ALDRIDGE TRANSPORTATION CONSULTANTS
Advanced Transportation Planning

RE: Transportation Impact Study
The Aurora Highlands Filings 7 Phases 1-3 I

Comments 6/8/2020:

Figure 4 AM Peak Hour Site Generated Trip Assignment

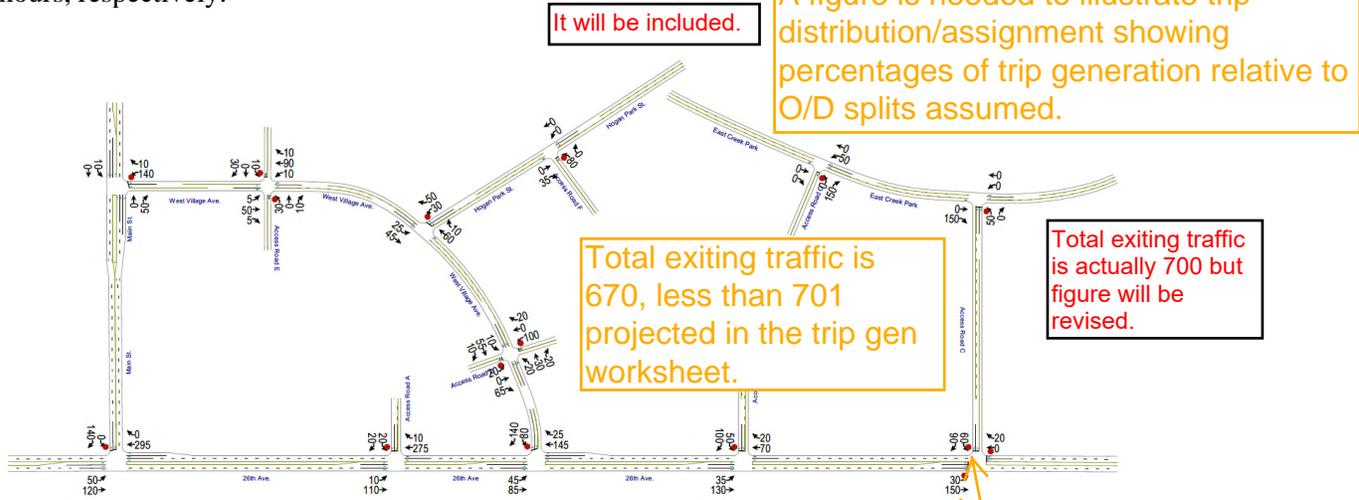
Assuming "directional" means in vs out, this should be a 75/25 split, per ITE trip gen rates.

Figure 5 PM Peak Hour Site Generated Trip Assignment

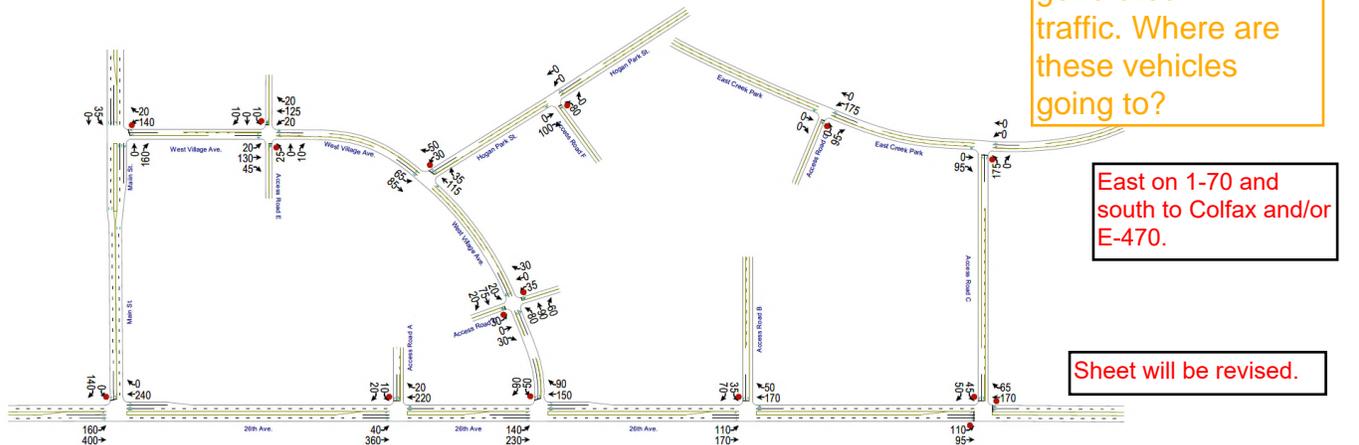
Total exiting traffic is 580, more than 461 projected in the trip gen worksheet.

Total entering traffic in this figure is 740, less than the 783 projected in the trip gen worksheet.

Figure 6 2040 Total Traffic per the FHU Study

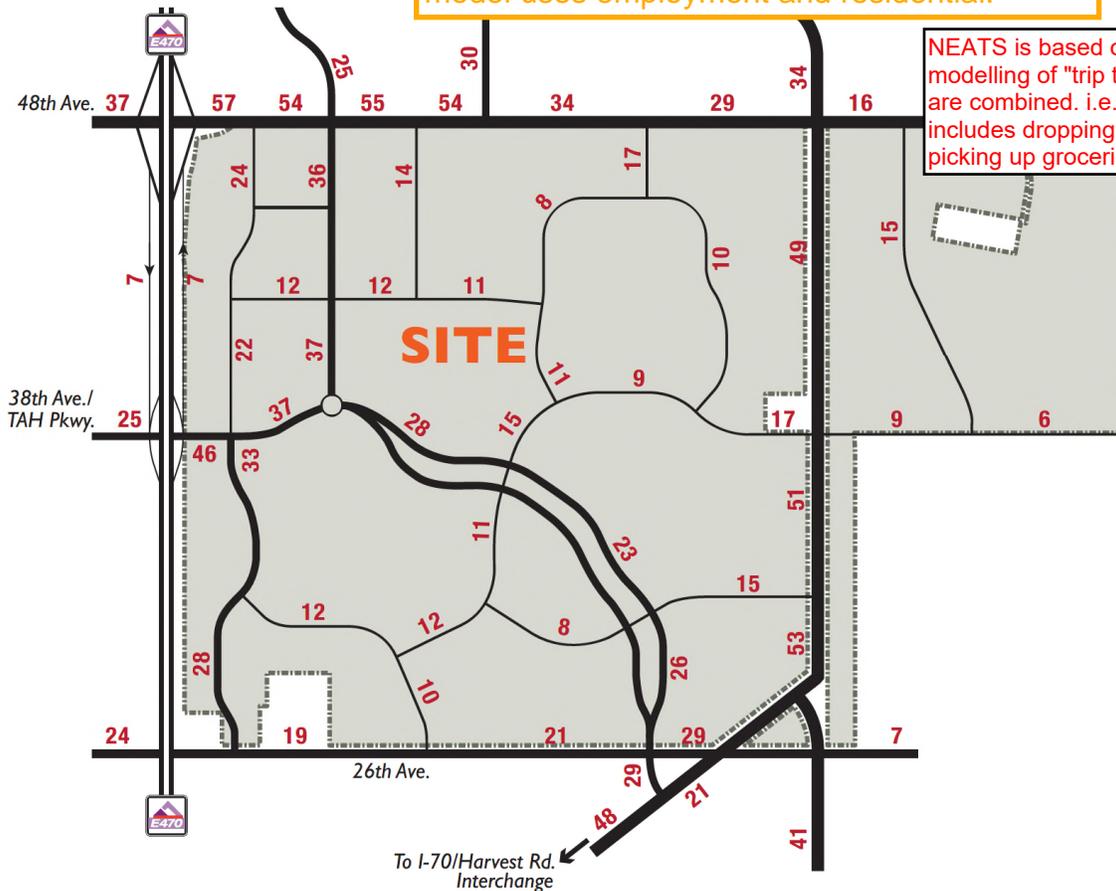
It appears that this assignment presumes full build out of TAH street network, given the high percentage of trips traveling to the east of this site on 26th, but this assumption was not stated in the text. If this assumes full build out condition, what is the trip distribution/assignment for the interim condition where access to the Metro region is limited to primarily only 26th Ave?

Yes, TISs use Trip Generation & the NEATS model uses employment and residential.

NEATS is based on DRCOG's travel modelling of "trip tours" where trips are combined. i.e. a trip to work includes dropping kids at school and picking up groceries on the way.

Figure 9 2040 AM Total

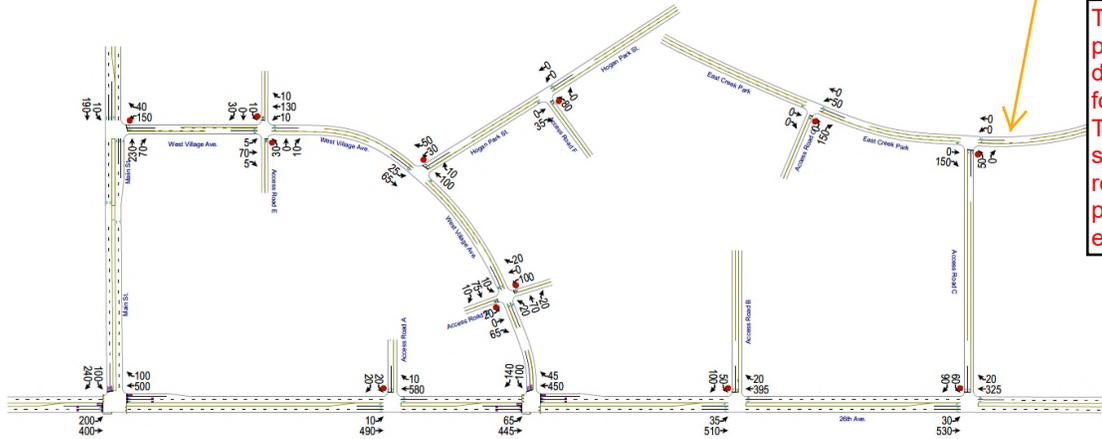
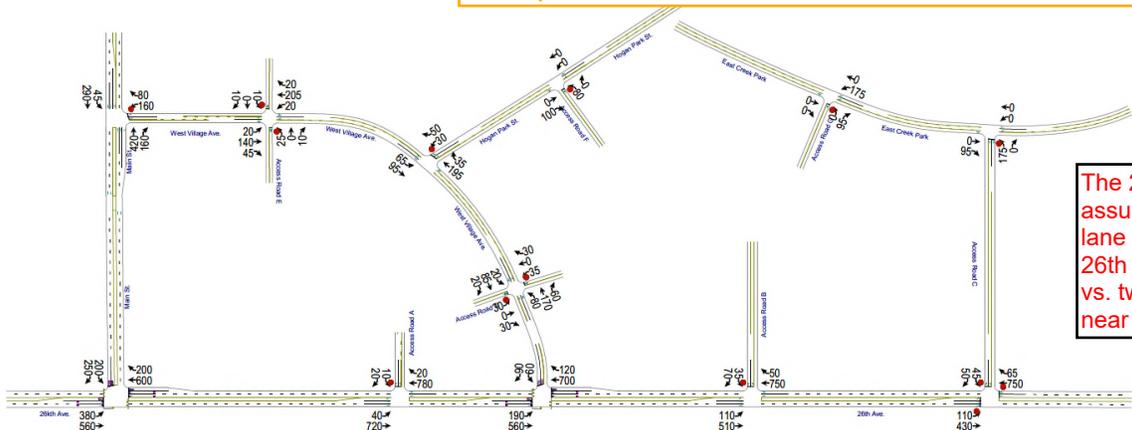
No trips coming from/going to The Aurora Highlands Pkwy in the 2040 scenario (AM or PM).

A final build out street network shall be assumed for an accurate 2040 analysis of traffic operations. This should differ from trip distribution/assignment on the more limited, near-phase street network.

These will be populated when development plans for the adjacent TAZs are submitted. The revised figures provide some estimates.

The 2040 network assumes a four-lane arterial on 26th and Main St. vs. two-lanes in the near term.
